Consolidated Edison Company of New York, Inc.  
4 Irving Place, New York, N Y 10003  
Telephone (212) 460-3819

May 11, 1978  
Re: I.P. Unit No. 2  
Docket No. 50-247

This transmittal is in response to Enclosure 2 to Mr. George W. Knighton's letter of July 26, 1977 to Mr. William Cahill requesting information relative to our request titled "Request for License Amendment to Eliminate Requirement for Termination of Operation with Once Through Cooling System" dated March 1977.

Enclosed please find the supplemental information requested relative to our responses to questions nos. V-5 (part 2) and XVI (part 2).

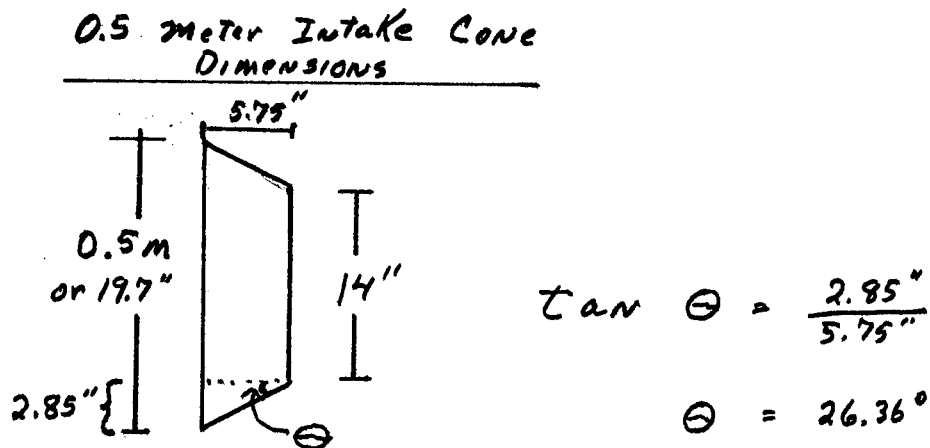
1. Please provide, with adequate documentation, the raw data on which this report is based [Part 2] Please indicate not only whether a velocity reduction cone was present or not but also the degree of taper.

In the NYU net mortality study, certain tests were conducted with velocity reduction cones at the mouth of the net. (These tests are indicated on the data sheets that were provided in response to this question)

The cone used in all the tests in which organisms were released was the half meter "intake cone". The degree of taper of this cone is about  $26.36^\circ$  which was calculated as follows:
